DECISION OF THE PLANNING ADMINISTRATOR

CLASS 3 SITE PLAN REVIEW / CLASS 2 ADJUSTMENT CASE NO.: SPR-ADJ25-11

APPLICATION NO.: 24-120825-PLN

New Retail Building
Fairview
2110 Strong Road SE - Salem, OR 97302

SITE PLAN C Attachment B

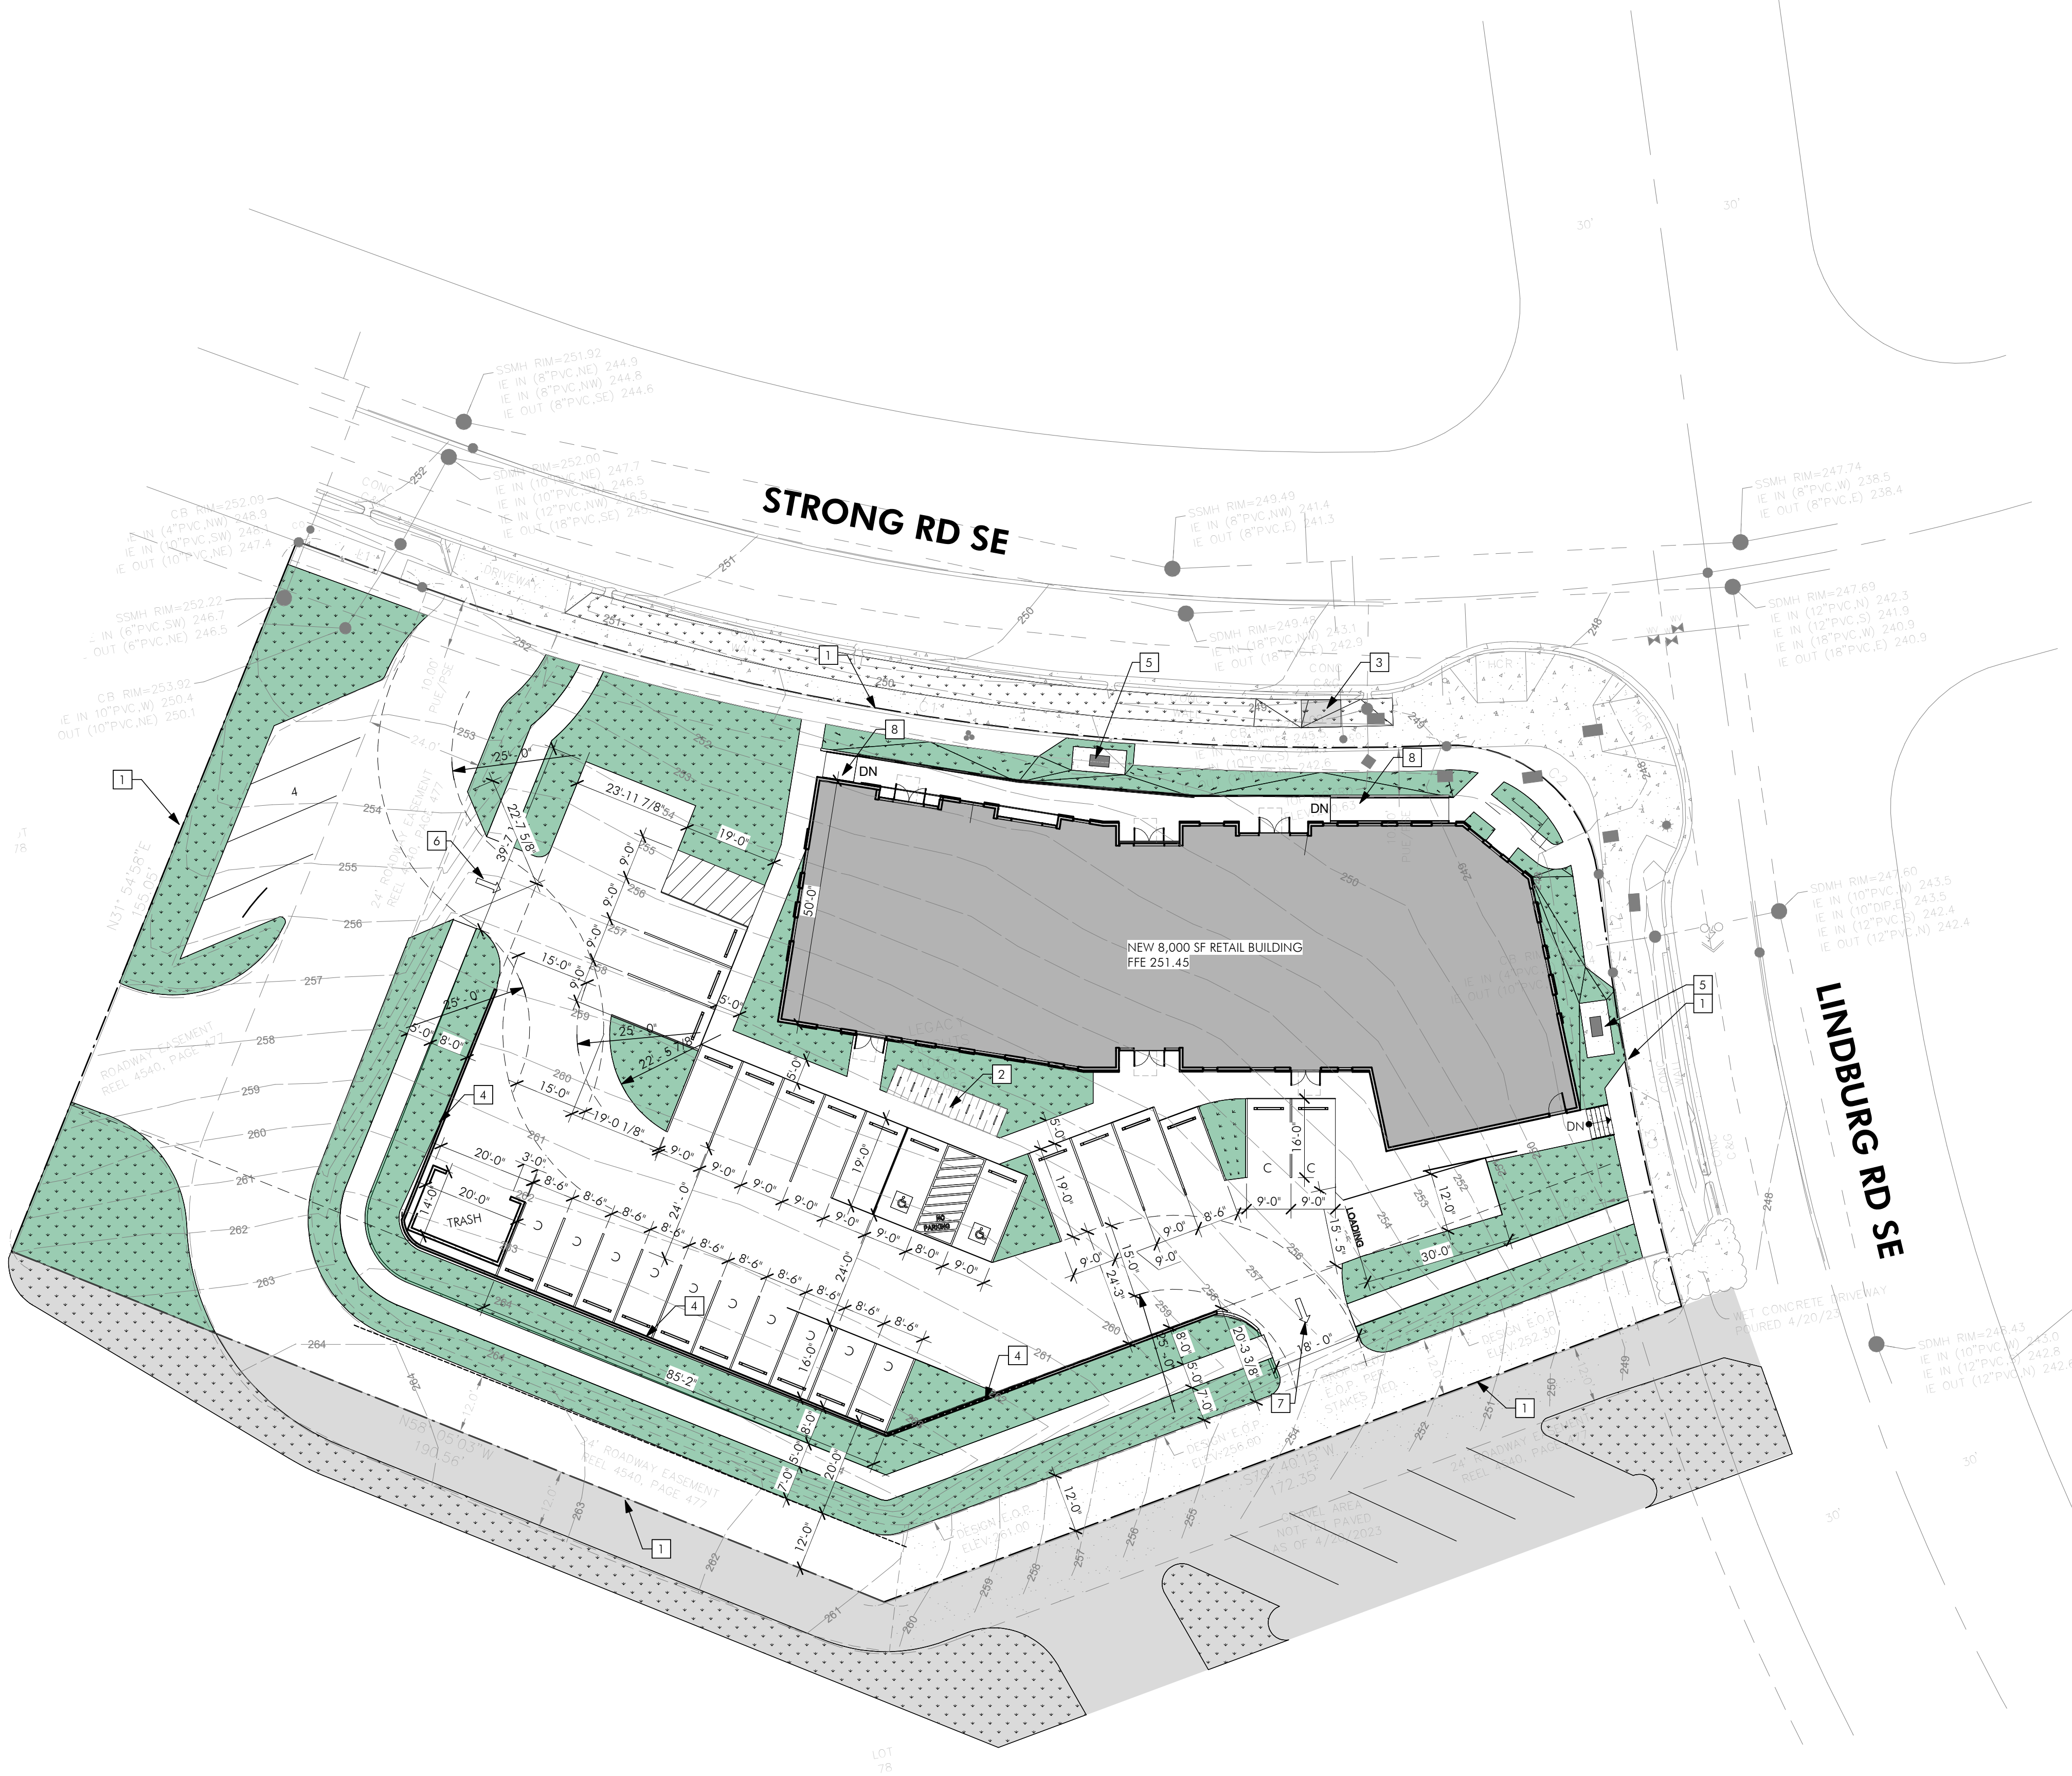
- 1) Maximum side street building setback abutting Village Center Loop. As shown on the site plan, the proposed building exceeds the maximum allowed 20-foot side street setback from Village Center Loop SE abutting the western property line of the subject property.
- 2) Minimum lot frontage abutting Strong Road and Lindburg Road. As shown on the site plan, the proposed development does not include a minimum of 70 percent of the lot frontages of Lindburg Road SE and Strong Road SE with buildings placed at the minimum setback line.
- 3) Minimum parking setback abutting street. As shown on the site plan, the off-street parking area to the south and west of the proposed building and the off-street loading space to the south of the building does not meet the minimum required 20-foot setback abutting Village Center Loop SE.

Exterior Wall Length. As shown on the site plan (**Attachment B**), the exterior walls of the building facing Village Center Loop to the west and Lindburg Road to the east do not exceed 100 feet in length, and the exterior walls of the building facing Strong Road to the north and Village Center Loop to the south include off-sets; thereby ensuring that no exterior wall of the building exceeds 100 feet without a minimum four-foot change of plane as required by this refinement plan standard.

As shown on the site plan, both standard size and compact size parking stalls are provided. The standard size off-street parking stalls conform to the minimum required 9-foot width and 19-foot depth and the compact size off-street parking stalls conform to the minimum required 8-foot width and 15-foot depth. All of the proposed parking spaces are also served by a drive-aisle which exceeds the minimum required width.

Vehicle access to the proposed development is provided by a private street, Village Center Loop SE, which loops around the perimeter of the property from Lindburg Road SE on the east to Strong Road SE to the north. As shown on the site plan, the proposed development includes two driveway approaches onto Village Center Loop that serve the 26 off-street parking spaces in the parking lot to the south and west of the proposed building.

The proposed development includes one trash enclosure/collection area meeting the definition of a solid waste service area under SRC 800.010. As shown on the site plan, the proposed trash collection area is located within a 20-foot-wide and 14-foot-deep enclosure with a front opening width of 14 feet for servicing.

Condition 5: Prior to issuance of a Certificate of Occupancy, widen the existing 5-foot sidewalk to an overall 10-foot-wide multi-use path along the development frontage of Strong Road SE and Lindburg Road SE in conformance with the Public Works Design Standards. Where there are existing utility vaults that conflict with the multi-use path, the sidewalk may meander around the vault, as shown on the applicant's site plan.

Condition 6: Prior to issuance of a Certificate of Occupancy, construct a 5-foot-wide sidewalk separated from Village Center Loop SE by a 7-foot landscape strip, as shown on the applicant's site plan and in conformance with the Public Works Design Standards.

Condition 9: The proposed off-street parking area and driveways shall be revised to allow two-way vehicle circulation rather than one-way vehicle circulation.

Screenshot of sheet A1.01 of site plan:

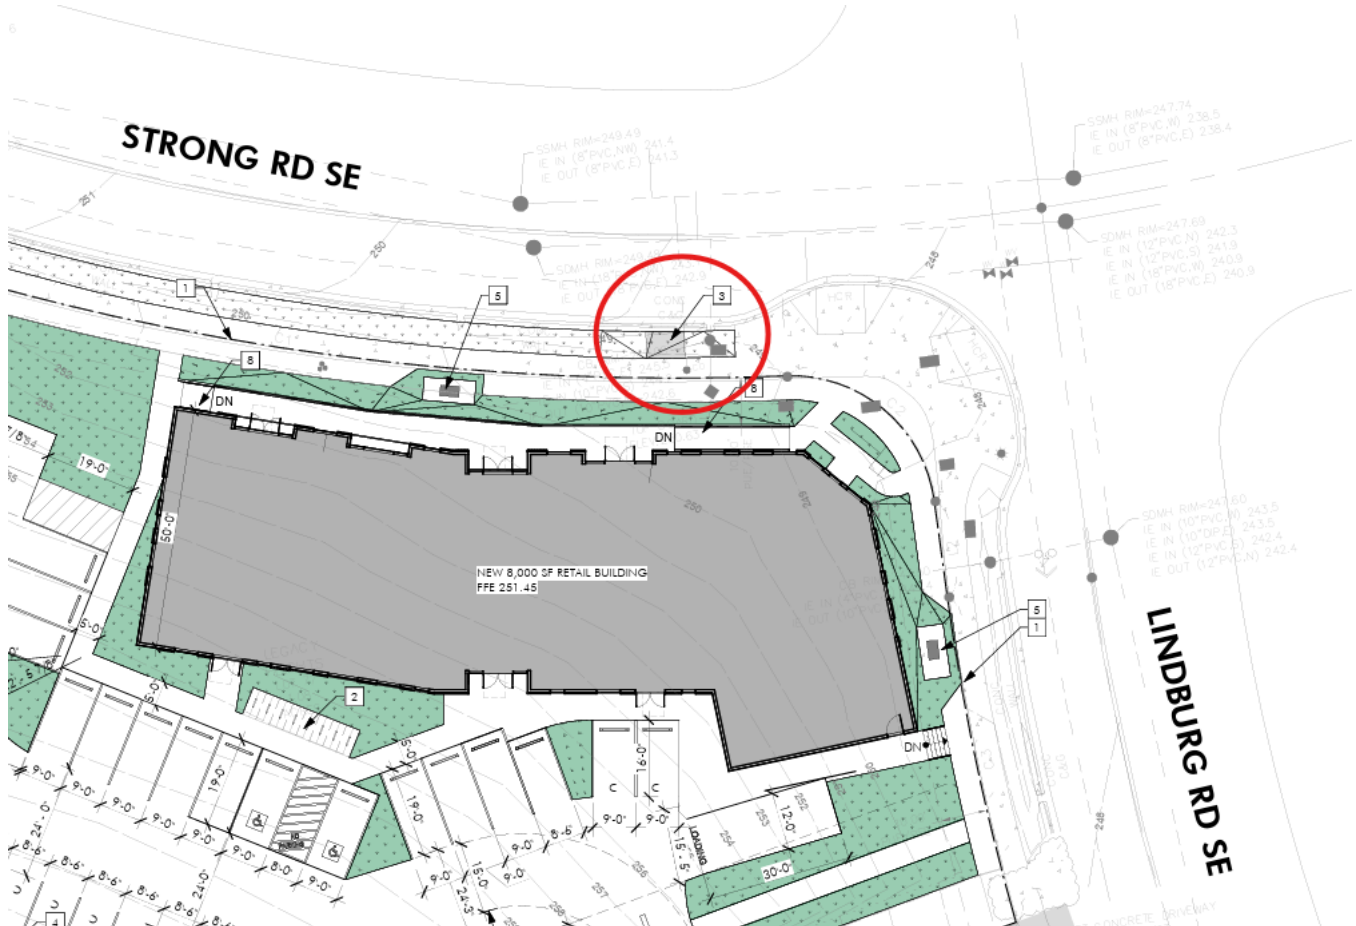
The transit stop shall be located on the south side of Strong Rd SE near the intersection with Lindburg Rd SE as depicted in sheet A1.01 of the site plan (see screenshot on following page). The transit stop shall be constructed as an ADA compliant front door landing pad with curbing, bridging the swale between the curb and sidewalk similar to the existing transit stop on the opposite side of Strong Rd SE. Photos of the existing transit stop have been provided in the following pages for reference.

To meet District and ADA requirements, the landing pad must be six feet wide with a cross slope of less than 2%. Each side of the landing pad shall have curbing running perpendicular to the roadway to prevent mobility devices from rolling off the edges of the pad (see photos for reference).
